New Albany Planning Commission Meeting Agenda
Monday, March 16, 2026, 7:00 p.m.

FDP-88-2025 Food Pantry Final Development Plan

ZC-09-2026 Clover Valley East Zoning District Rezoning

Re: Healthy NA Food Pantry
Final Development Plan

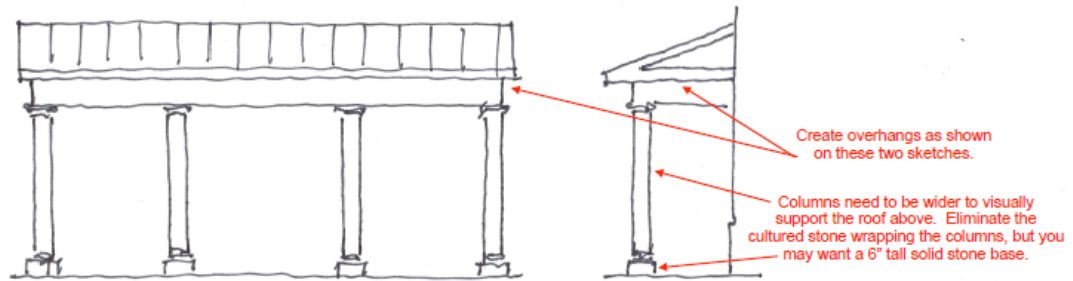
- Provide a taller roof pitch on cupola.

- Create overhangs as shown on the sketch below

- Columns should be wide to visually support the roof above. Eliminate cultured stone wrapping the columns and use a 6' tall solid stone base.
- Align neck of columns.

1 LANDSCAPE PLAN
 SCALE: 1/30" = 1'-0"

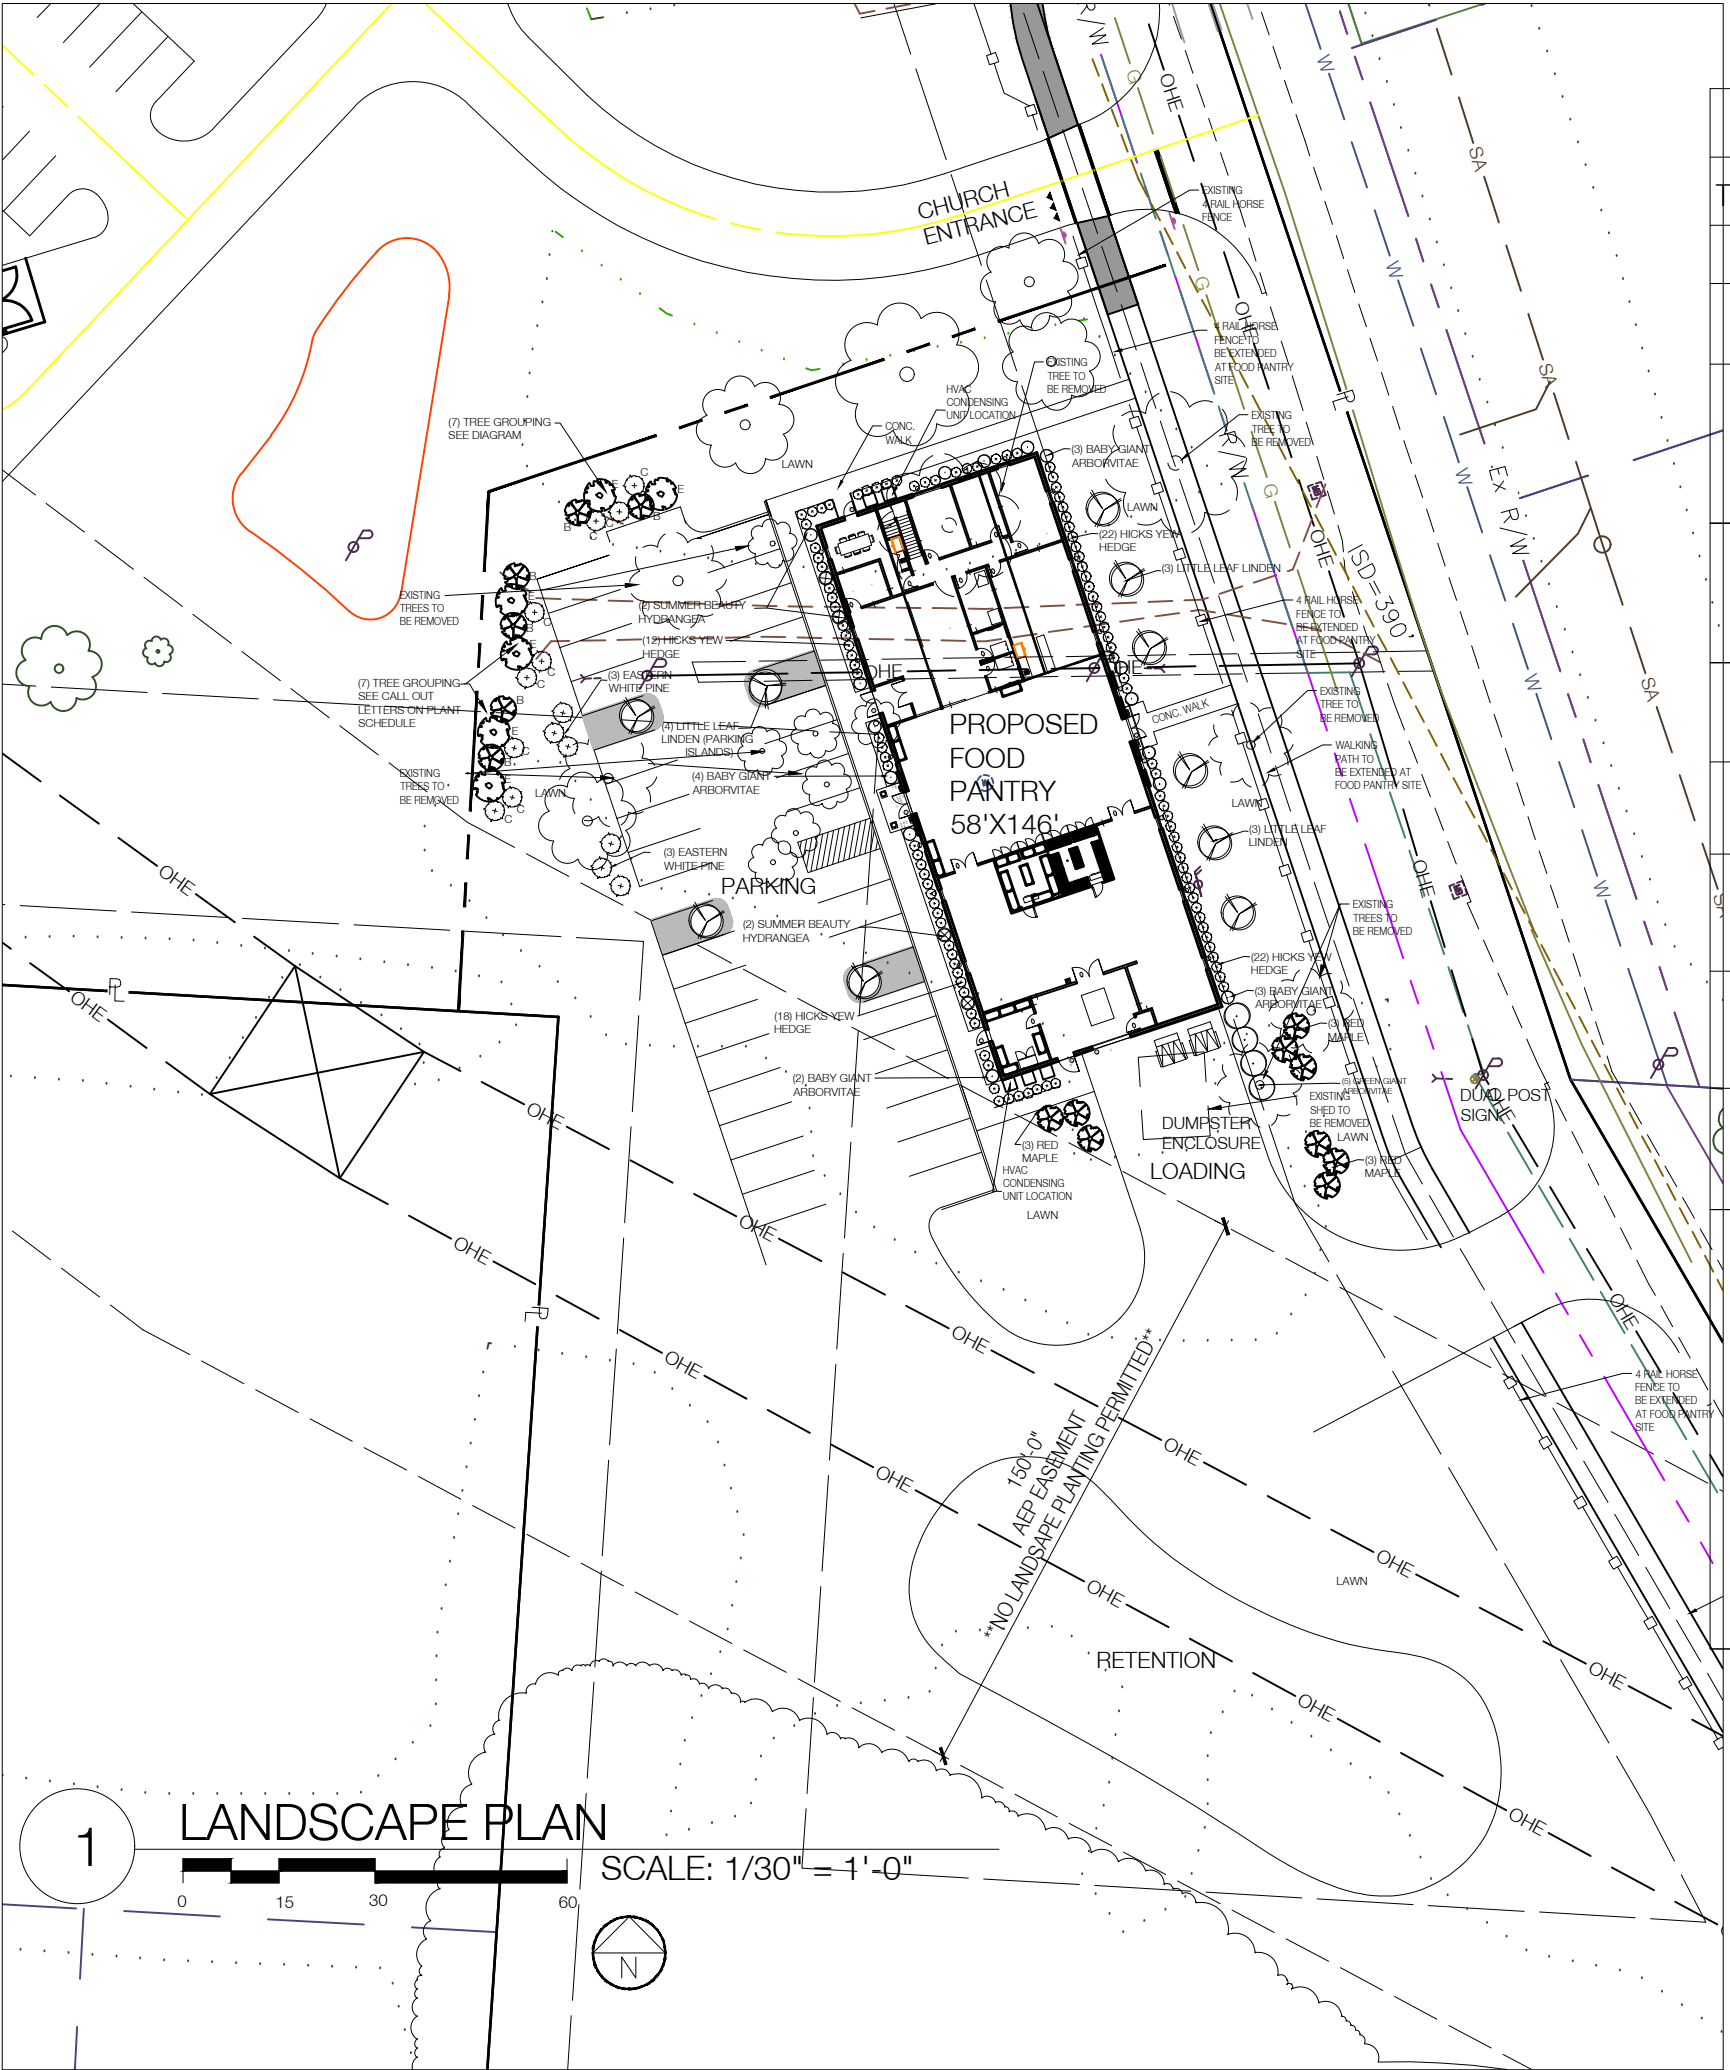
2. Revise the proposed landscape plan to remove the use of Green Giant Arborvitae (*Thuja plicata x standishii* 'Green Giant') at the edge of the parking lot. Replace screening material with deciduous shade trees. See below.
3. Recommend the adjustment of the proposed retention basin location to avoid the removal of the existing tree stand as outlined on sheet L102 of the submitted materials. See below.
